Some corrections that may significantly improve the already very famous TS-940S receiving performance.

Dedicated to the Detailists

Two errors that I found, both also showed in the Service Manual, Revised Edition.

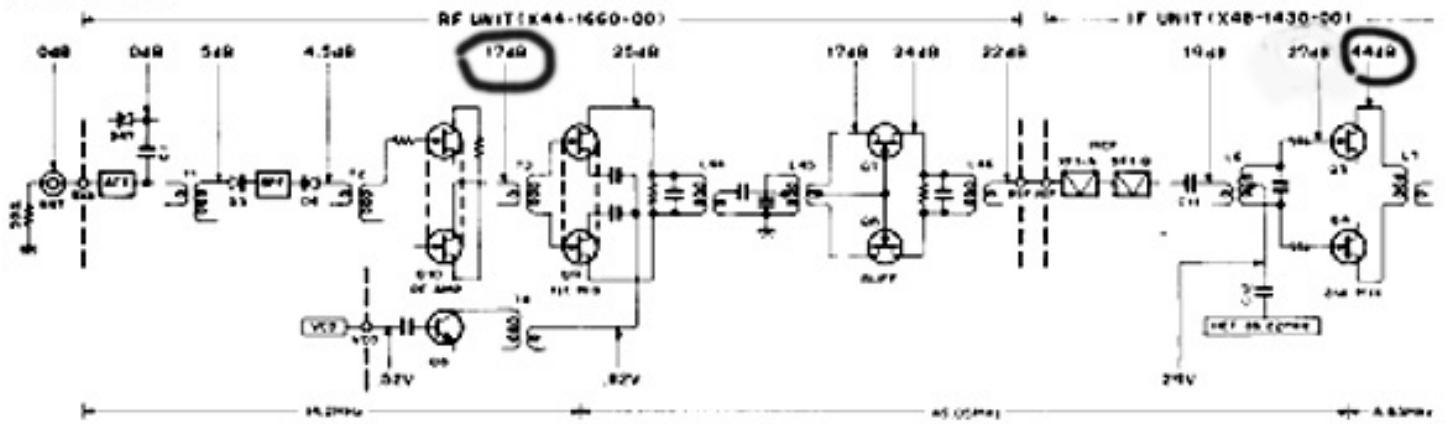
See the FETs Q10 (RF Preamp RF Preamp 2SK125, N-FET, 25V, 0.1A, 0.3W) and Q4 Q5 (2nd balanced mixer, also 2SK125).

The picture above was scanned from the TS-940S Service Manual, Revised Edition. In these pictures the FETs are in the wrong position.

See the Level Diagram in the Service Manual. With the FETs on the right position, we would have 12.5 dB (17 - 4.5) gain in the RF Preamp, and 17 dB (44 - 27) in the 2nd balanced mixer at the indicated points in the picture above. These gain values are related to the 0 dB input. It would be interesting to measure these gains before the correction. With this measurement we would have an idea about the sensitivity losses due to the two errors.

My radio was working apparently well. This is the 1st TS-940S that I could observe and analyze in detail its circuits. First I found the RF Preamp FET in a odd position, but only few days after I could focus and see that the cascode circuit was correct in the schematic diagram and wrong in the PC board. It was also wrong in the PC board view pictures in the Service Manual.

I also noticed that a FET was hotter than the other. It was as simple as de-soldered and turn the FET 180° and re-solder it all over again.
